KWM-380 TRANSCEIVER (622-5093-101)
HF-380 TRANSCEIVER (622-3580-101)
RECEIVER-EXCITER CIRCUIT CARD A3 (638-6908-001)

SERVICE BULLETIN NO 1**PRODUCT IMPROVEMENT**

This is a nonmandatory service bulletin which applies to the following:

P/O Synthesizer Variable Reference Frequency Loop A5A2
Figure 1

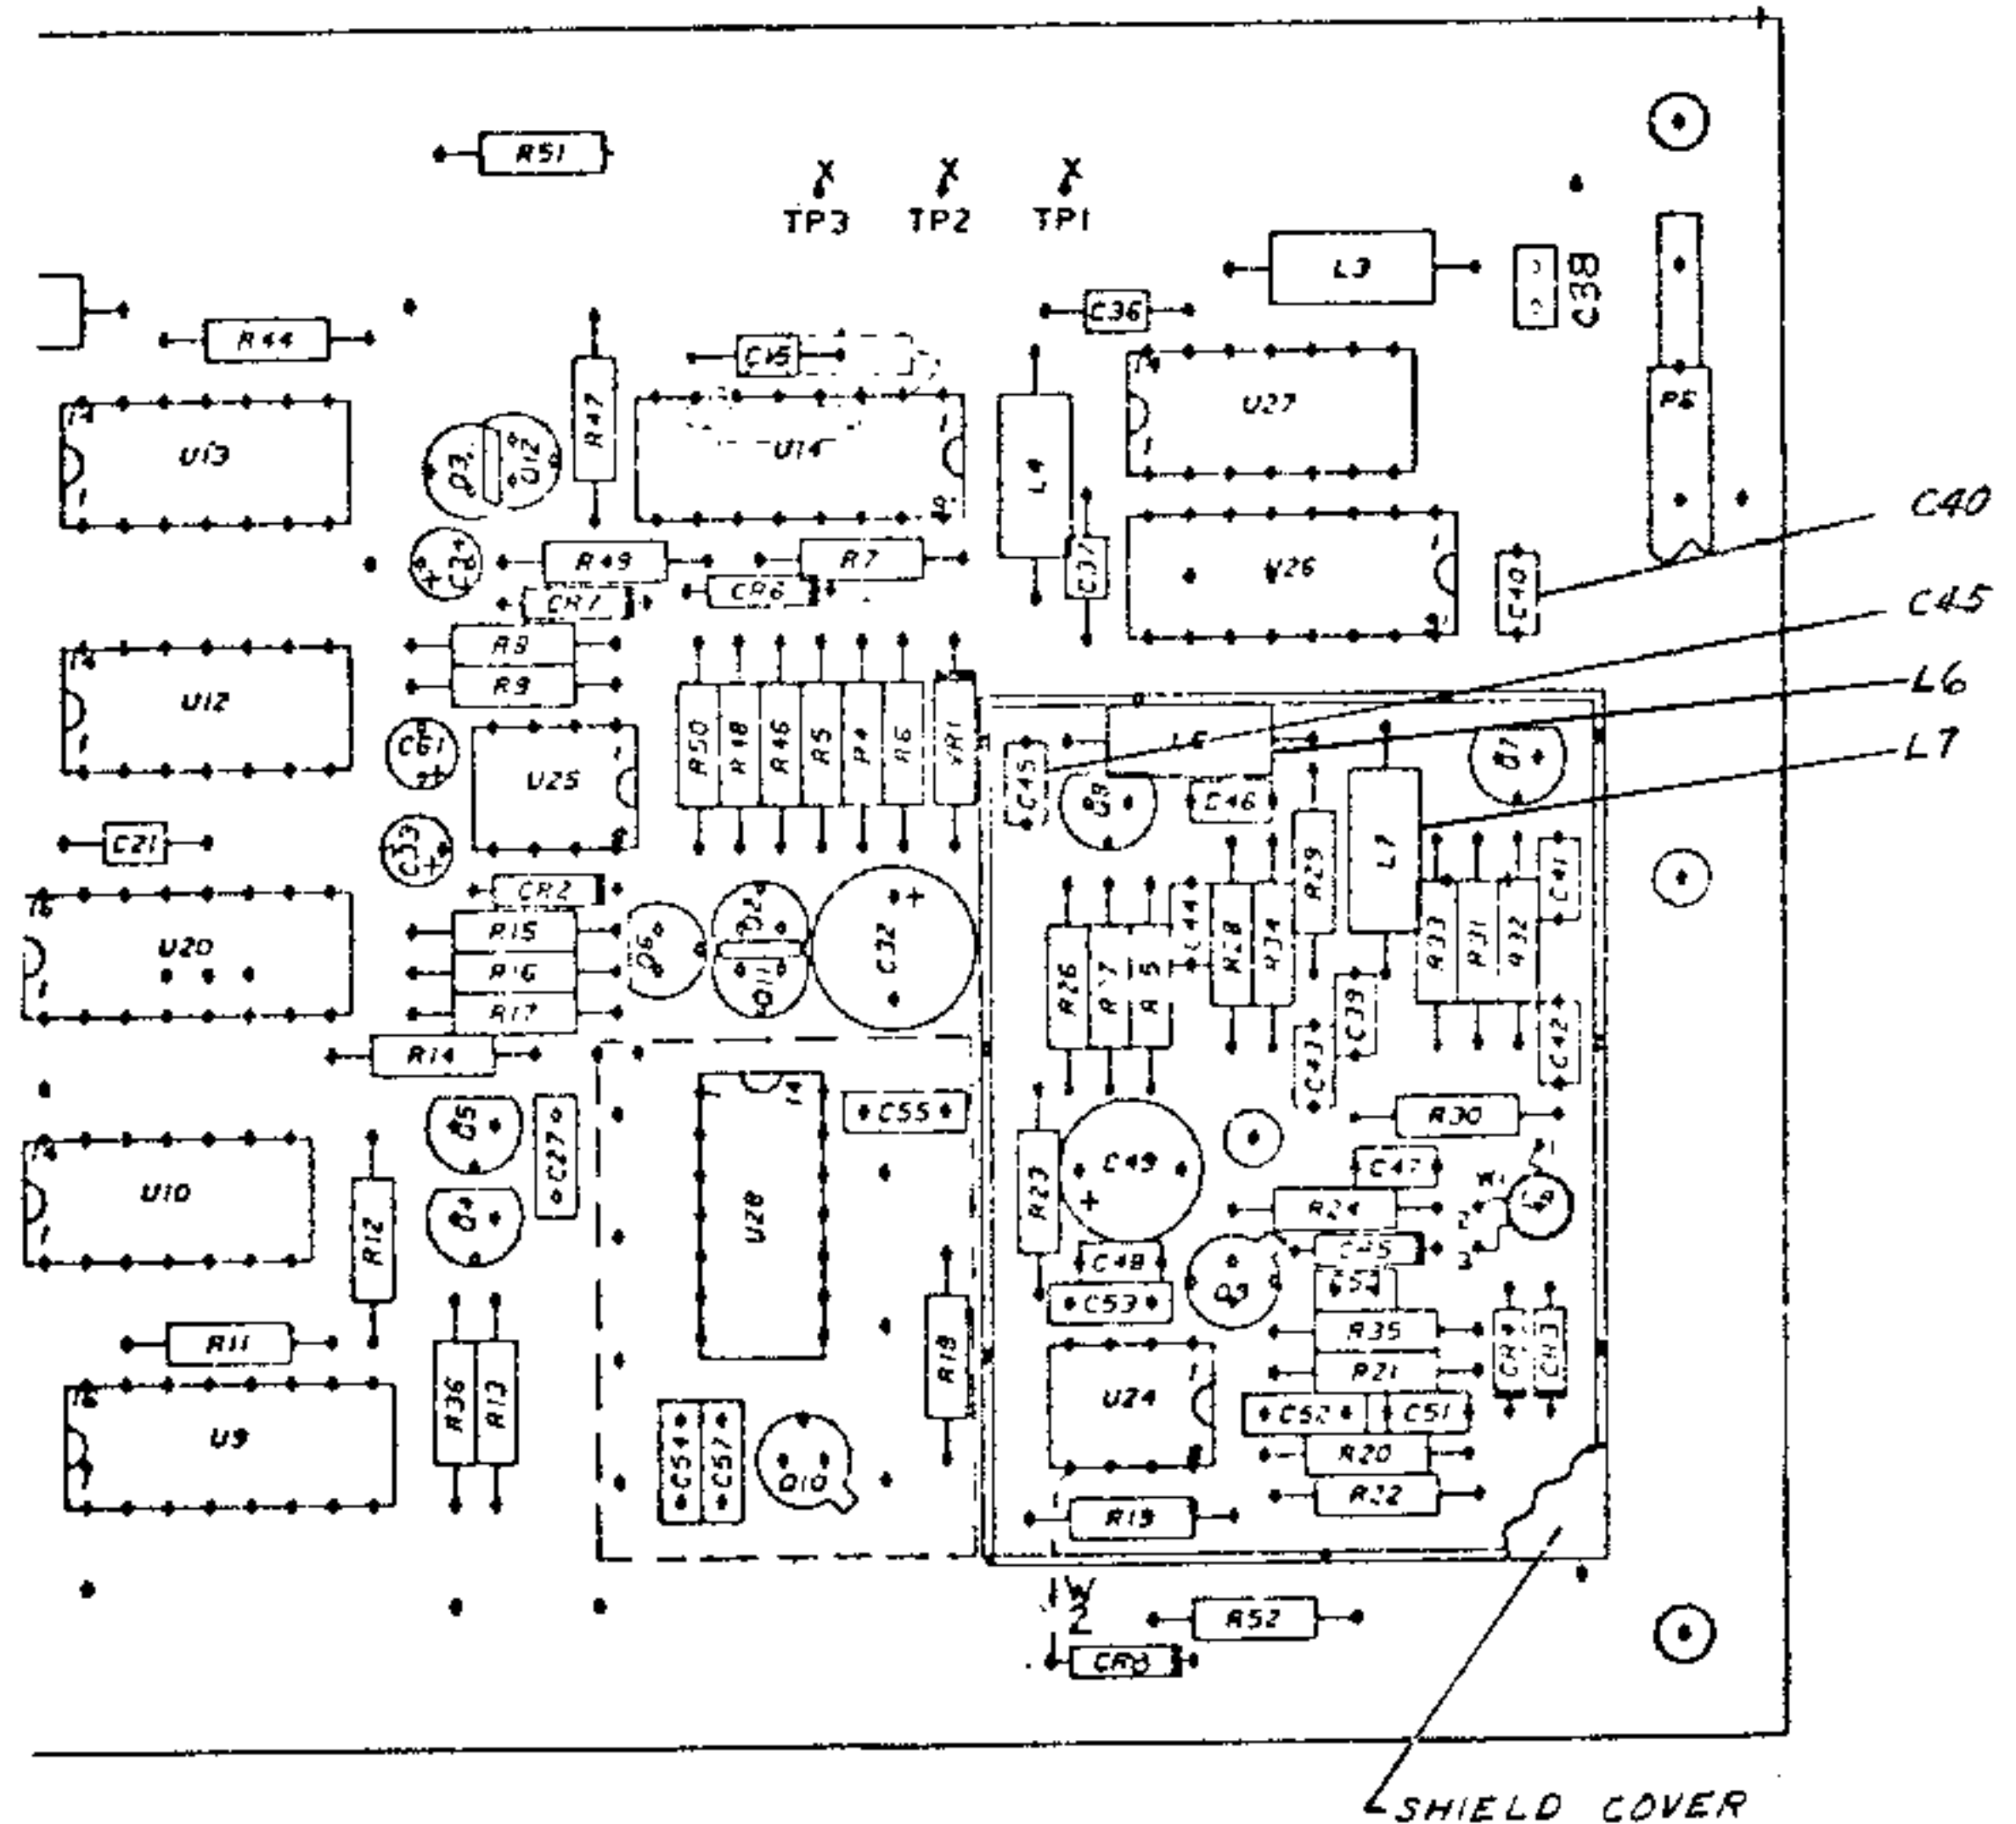
- F. Remove shield cover by removing seven screws.
 - G. Remove coils L6 and L7 and replace them with new 0.15 μ H coils (240-1562-000).
 - H. Remove capacitors C40 and C45 and replace them with new 4 pF capacitors (912-4141-080).

KWM-380/HF-380 Front Panel, Rear View
Figure 1

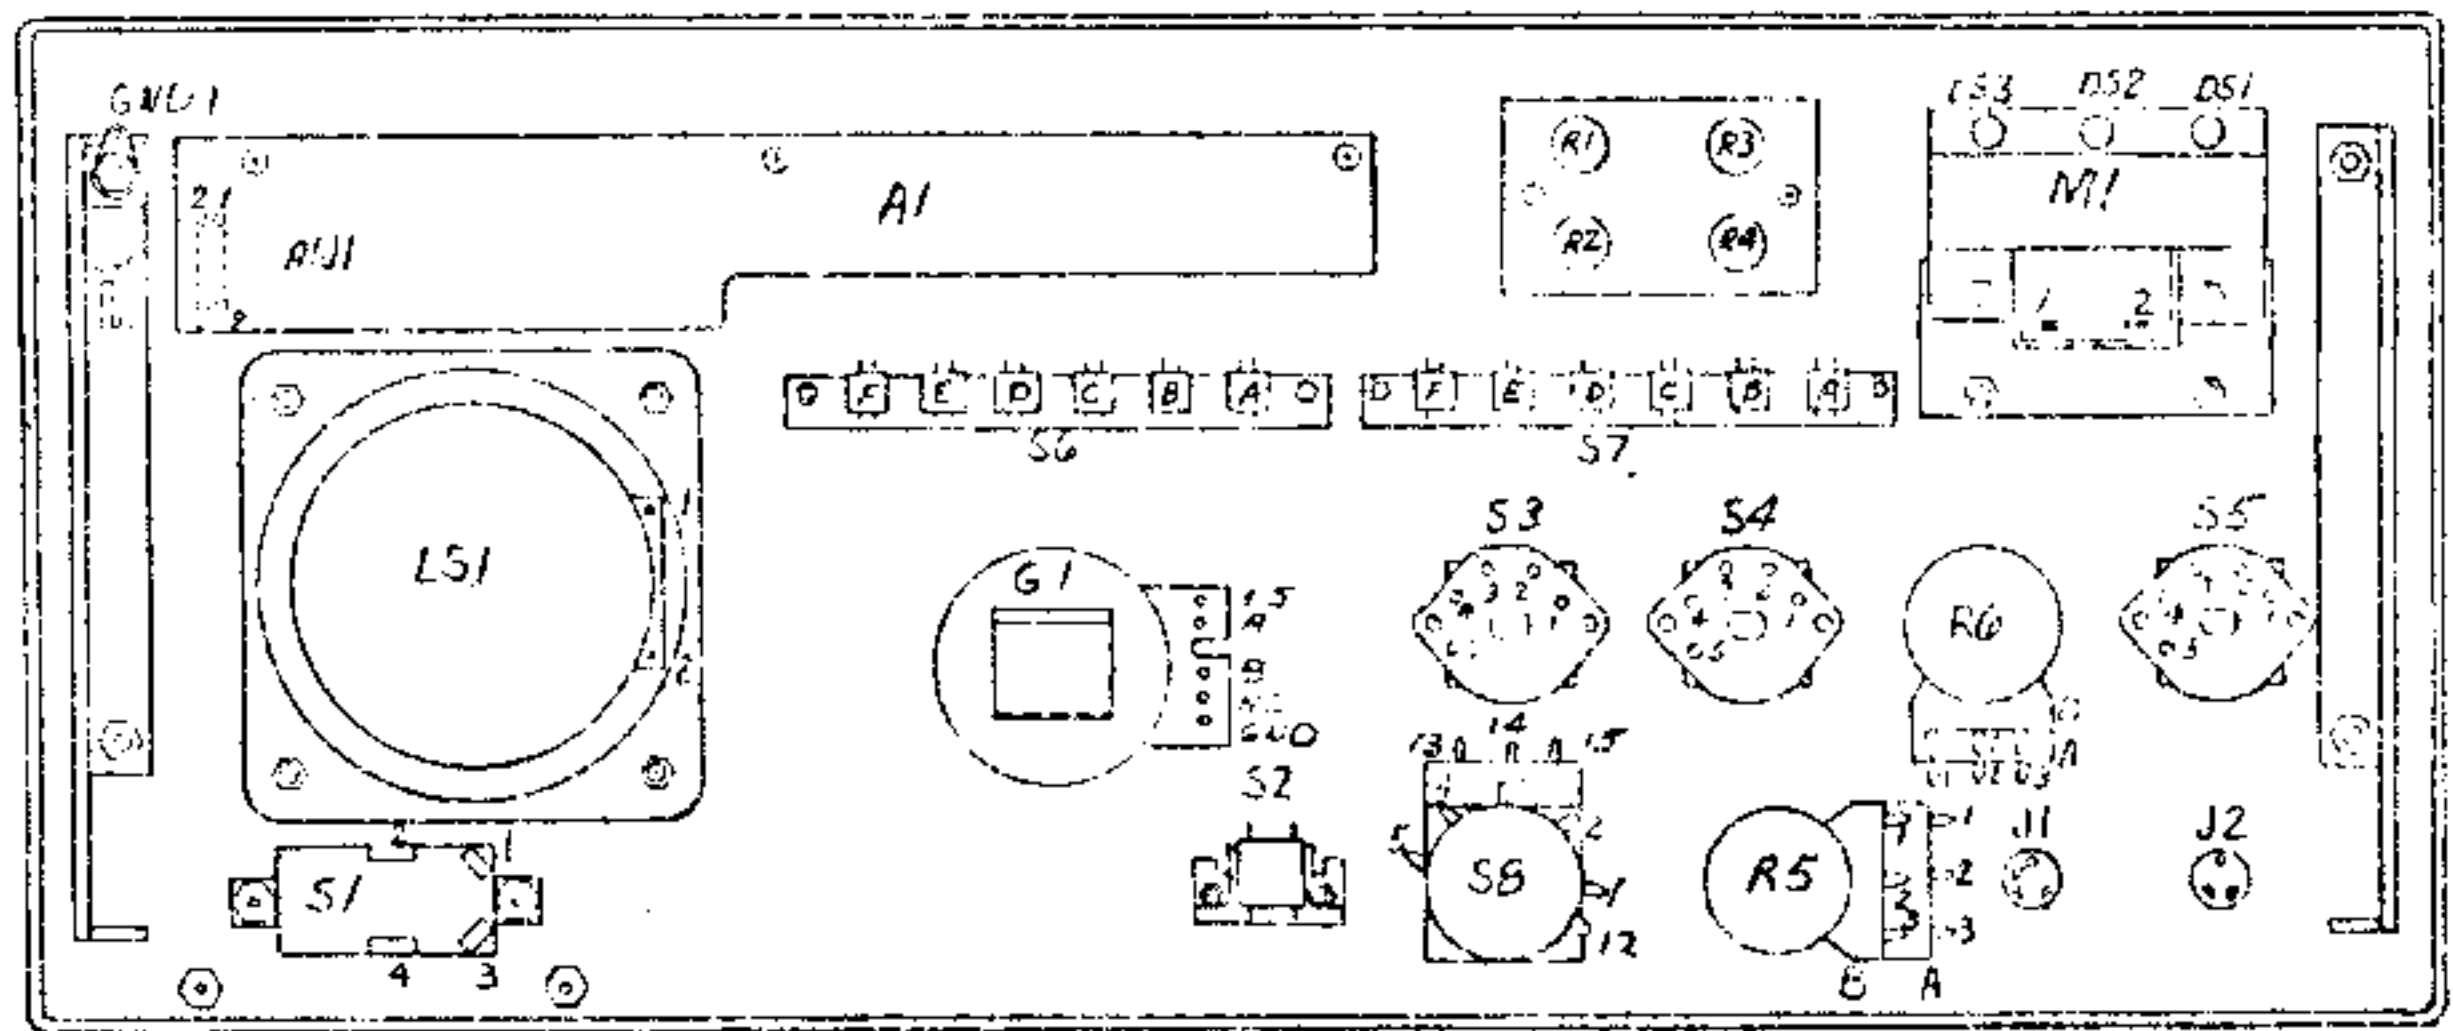
- D. Remove R5 by removing one nut and one lockwasher.
- E. TAG AND REMOVE the wires connected to tandem potentiometer R5.
- F. Connect the wires that were removed in step E to the new R5.
- G. Install new potentiometer R5 (376-0276-050) using the nut and lockwasher supplied with the pot.
- H. Solder all electrical connections.
- I. Reinstall the AF RF GAIN knobs and tighten the setscrews in each knob.
- J. Reinstall the dust cover.
- K. Mark SB 5 on the service bulletin information chart. If the transceiver does not have an information chart, install a chart (280-3778-010) near the nameplate.

KWM-380/HF-380 Front Panel, Rear View
Figure 1

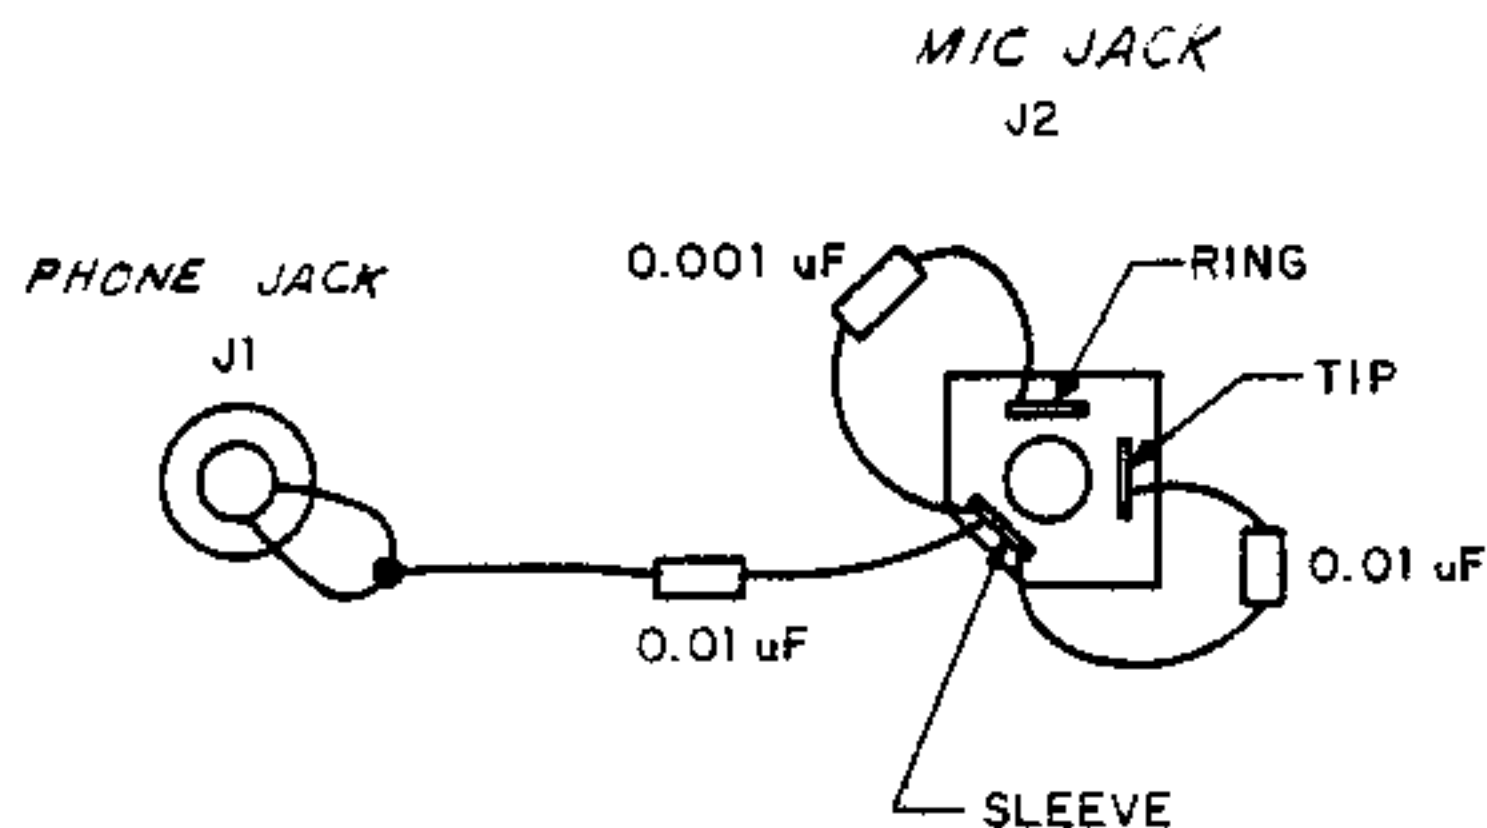
- C. Unsolder and remove the wires connected to mic jack J2 (figure 1).
- D. Remove and discard J2 by removing the nut that secures the jack to the front panel. Discard the bypass capacitors mounted on the jack.
- E. Install a new jack (647-2739-001) with the orientation shown in figure 2 using a black nut (334-1657-020).
